Ardleigh Parish Council Response to National Grid Norwich to Tilbury DCO Application

Report on Proposed Route Alignment and EACN Substation Siting in Ardleigh

Revision: 1

Date: 26 January 2026

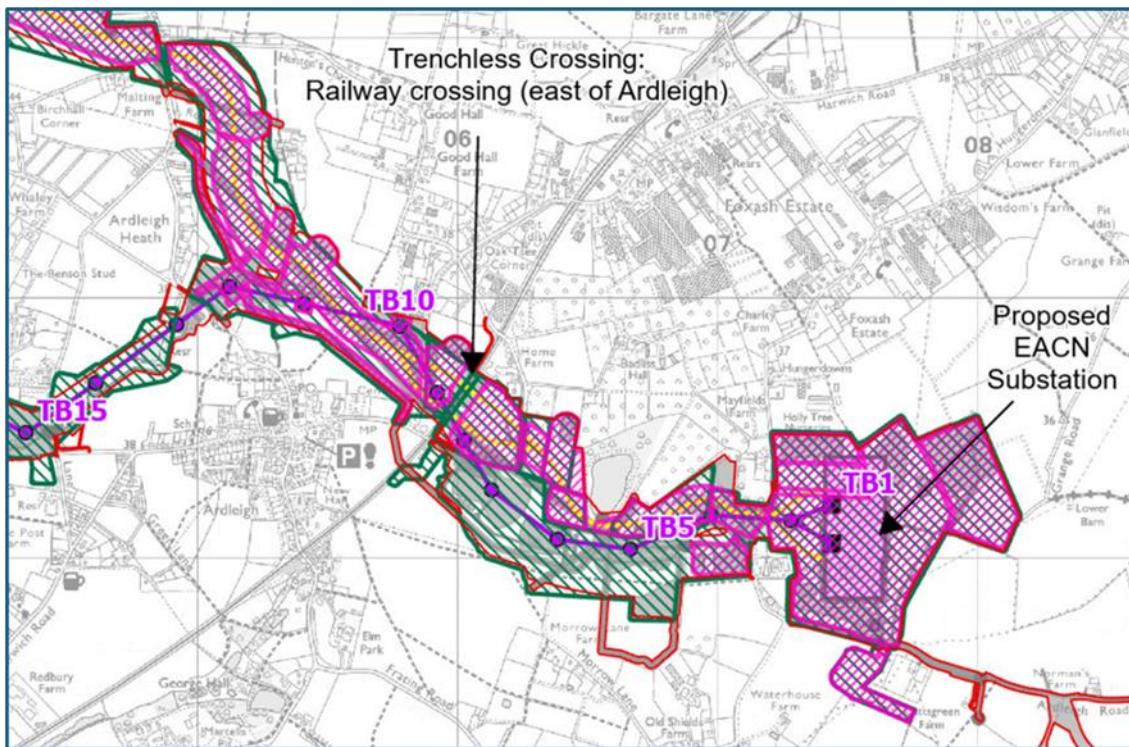
5.24 The proximity of the proposed infrastructure to land immediately to the north of the Scheduled Monument “*Crop mark site S of Ardleigh*” (1002146) is also of great concern in relation to non-designated heritage assets in the area.

At the closest point the proposed Order Limit aligns with the northern boundary of the Scheduled Monument site.

NGET Figure A11.1: Historic Environment Designated and Non-Designated Heritage Assets
Page 13 of 25: Drawing No. 10059280-ARC-ELS-ZZ-DR-ZZ-00188 Rev. A

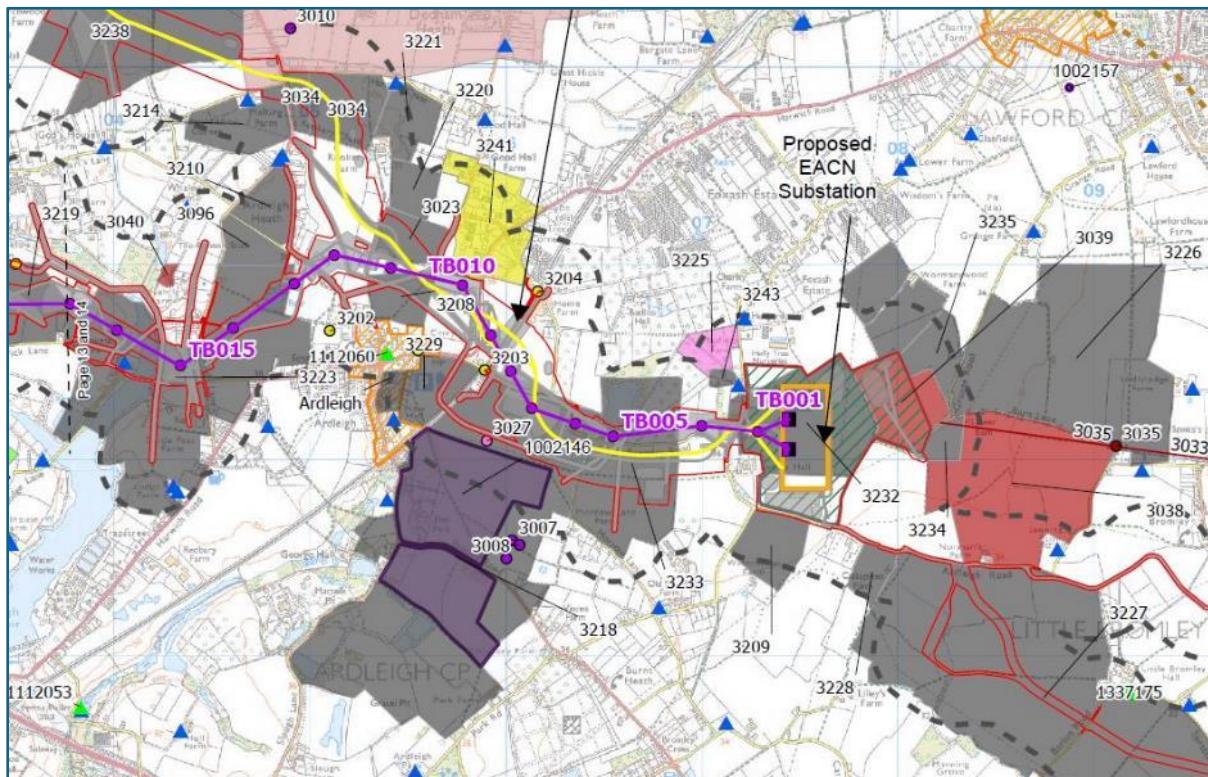
It should be noted that there are 17 listed buildings in the Conservation Area (16 Grade II and 1 Grade II*) and therefore considerably more than shown on this plan.

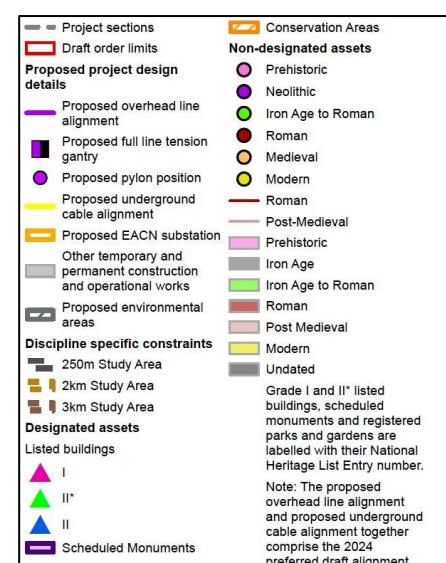
Similarly, the plan “Norwich to Tilbury - Environmental Constraints - Section C.pdf” shows just 2 of the 17 listed buildings in the Conservation Area (National Grid Drawing Reference: AENC-NG-ENG-PLN-0012, SHEET 11 OF 16, Issue A, Date: APRIL 2024).

NGET Figure A11.1 modified to show Areas A & B, as identified in EAA Report 90 and the additional Roman Roads.

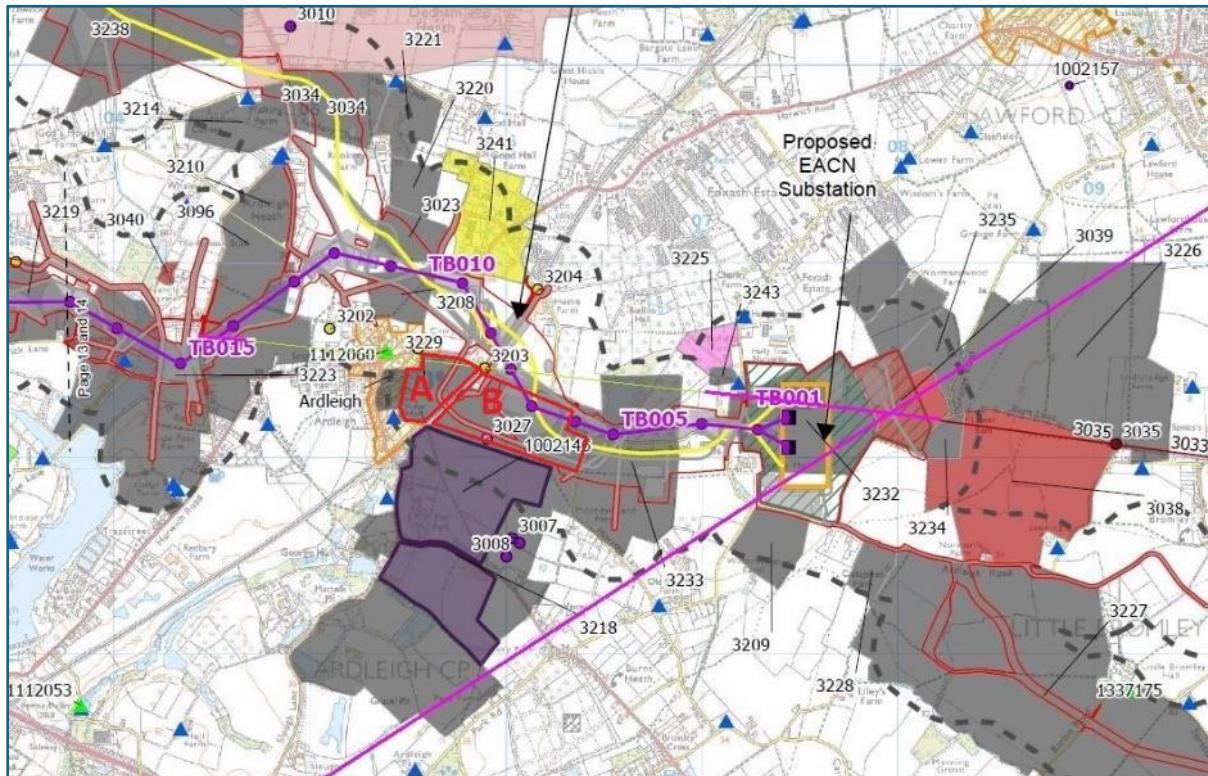
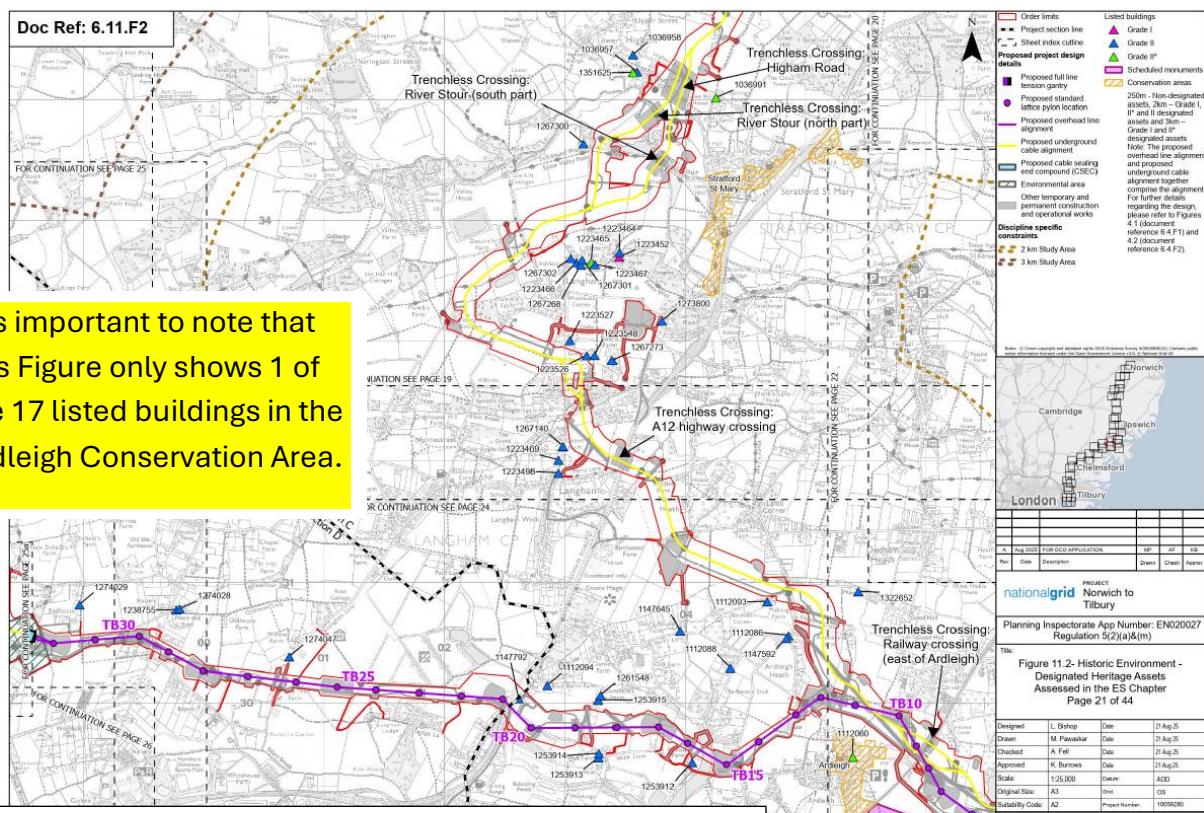
5.9 The non-designated heritage assets map shown in Appendix C-4 also does not consider the additional assets highlighted by Ardleigh PC in its Statutory Consultation submission, as shown in the modified map in Appendix C-2. These are the Areas A & B, as identified in EAA Report 90 and additional information on the Roman Roads 3033/3035 and MEX9020 which intersect the proposed EACN site. (MEX9020 is the reference number used in the EACN Substation Geophysical Survey Report obtained by NGET.)

Appendix C-3: Designated Heritage Assets – DCO Application

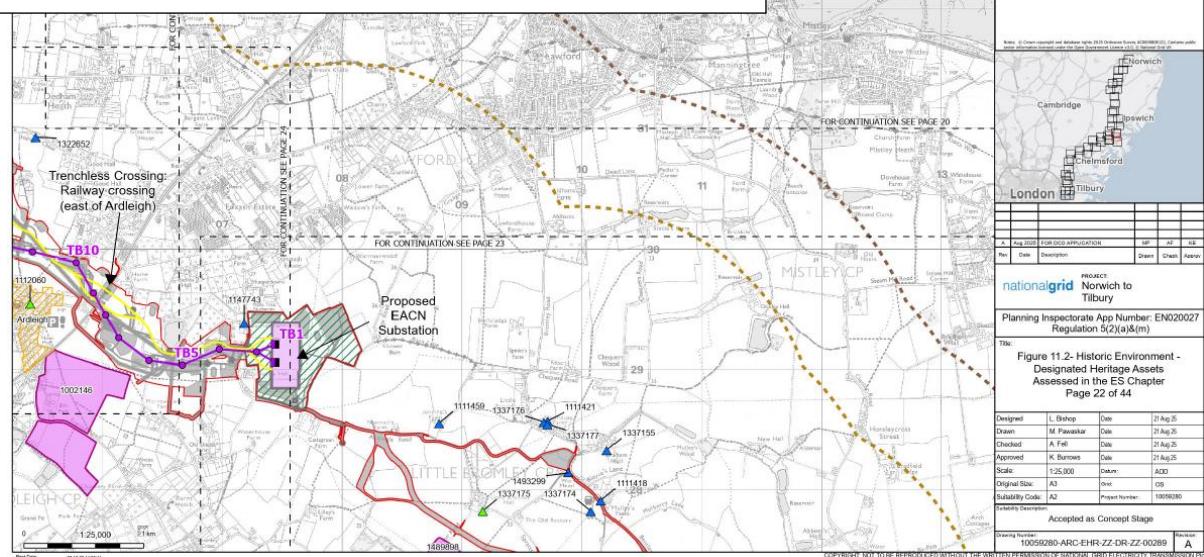
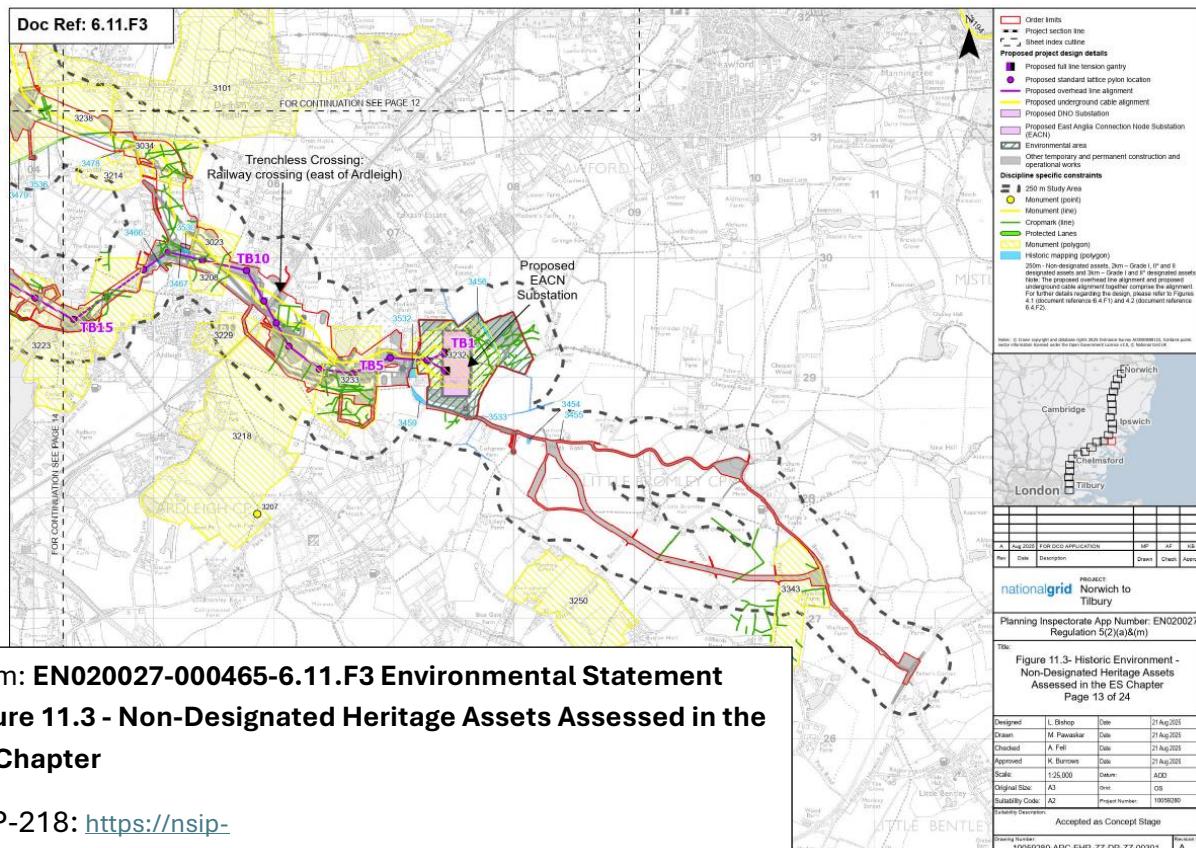
- **17 Listed Buildings out of a total of 71 Listed Buildings in the Parish.** One of these is the Grade II* Church of St Mary (1112060). The remaining 16 are Grade II. *It is important to note that Figure 11.2 in National Grid’s DCO application (APP-217) only shows 1 of the 17 listed buildings in the Ardleigh Conservation Area.*

Increase in length of route and cost due to the currently proposed route diversion

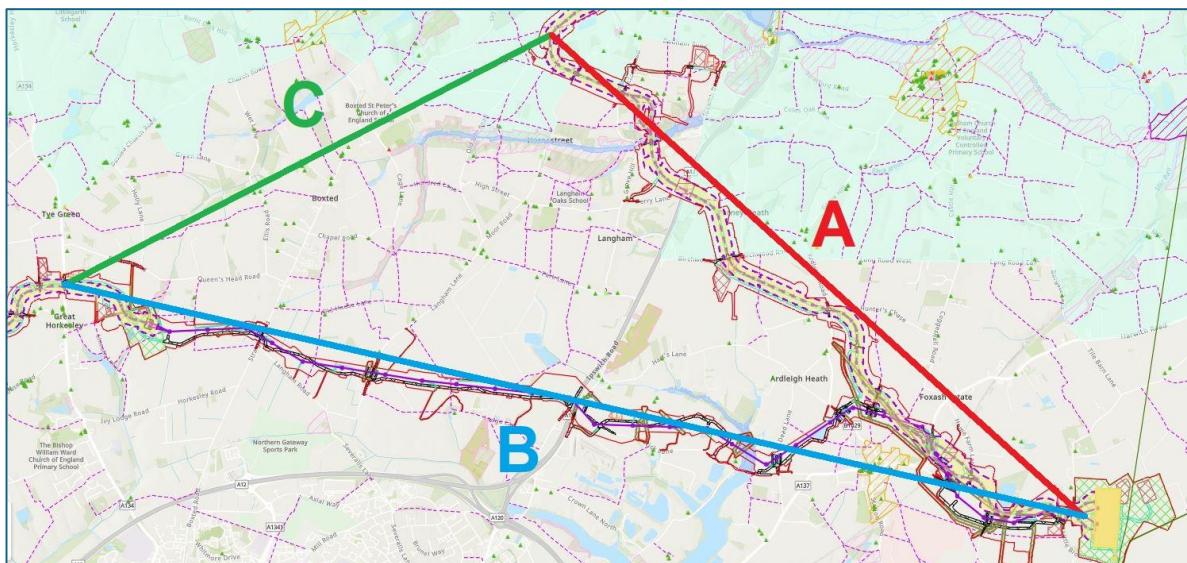
7.8 The calculations, which are presented in Appendix E-1, show that a route diversion into Ardleigh results in an additional Lifetime Power Transfer cost of approximately £154 million, almost doubling the cost of this section of the Norwich to Tilbury route.

7.12 Straight routes were assumed for this comparison with an additional 0.77 km added to “Segment B” in the calculations to account for the length increase resulting from the exceptional serpentine OHL route proposed around Ardleigh village centre between TB3 and TB21. This increase in length alone results in an additional cost of £5.5 million, as established from the calculations in Appendix E-1 (using the 2025 IET figures). The additional cost is likely to be substantially higher than this due to the excessive number of angle towers required. The previous version of the IET report²¹ discusses how the cost increases significantly in such situations.

Additional route length: **12.23 km**
 Additional Lifetime Power Transfer cost: **154.39 £ million**

Appendix G-1: Alignment of towers TB-1 to TB-21

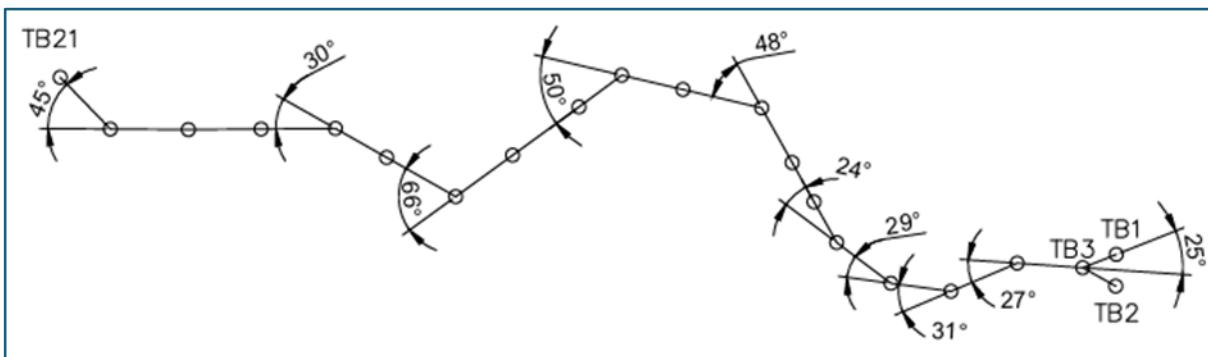
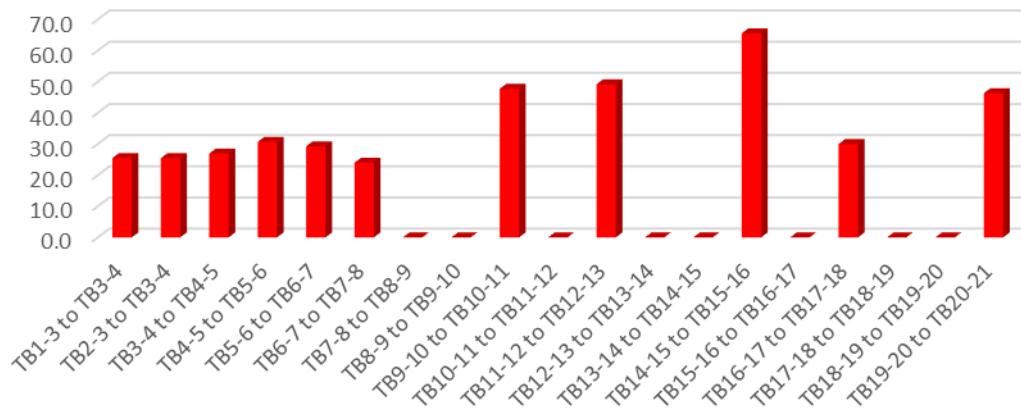
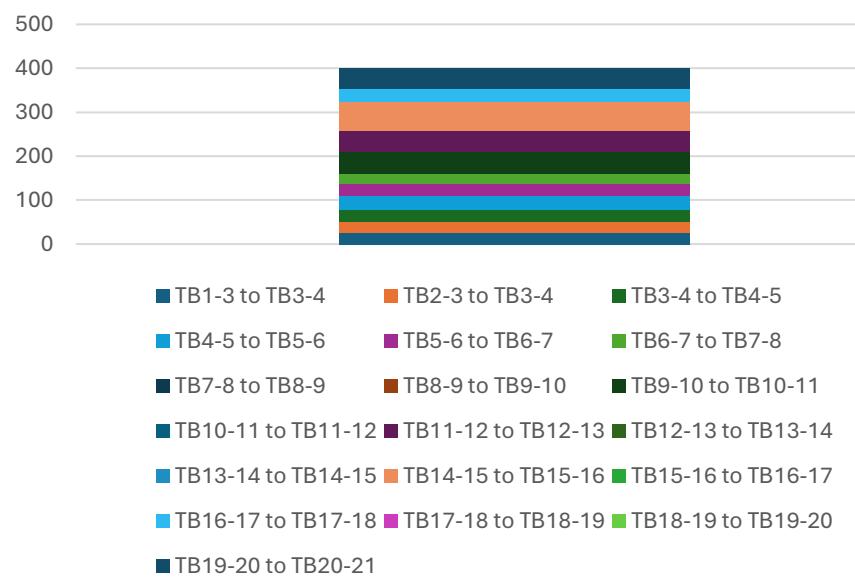
7.25 The calculations show that between TB1 and TB21 the average difference in alignment from one cable span to another is approximately 21° . Four of the spans are at an angle greater than 45° and one of these is at an angle of 65° . The greater the misalignment of each span, the more visually intrusive the angle pylons become due to increase in the length of the cross arms and the greater asymmetry.

7.26 The total cumulative misalignment in this section is approximately 400° . This therefore represents an overall change in alignment equivalent to more than a full circular rotation, and this occurs within a linear distance of only 5km between the start and end points. The calculations and the charts presenting the results are provided in Appendix G-1.
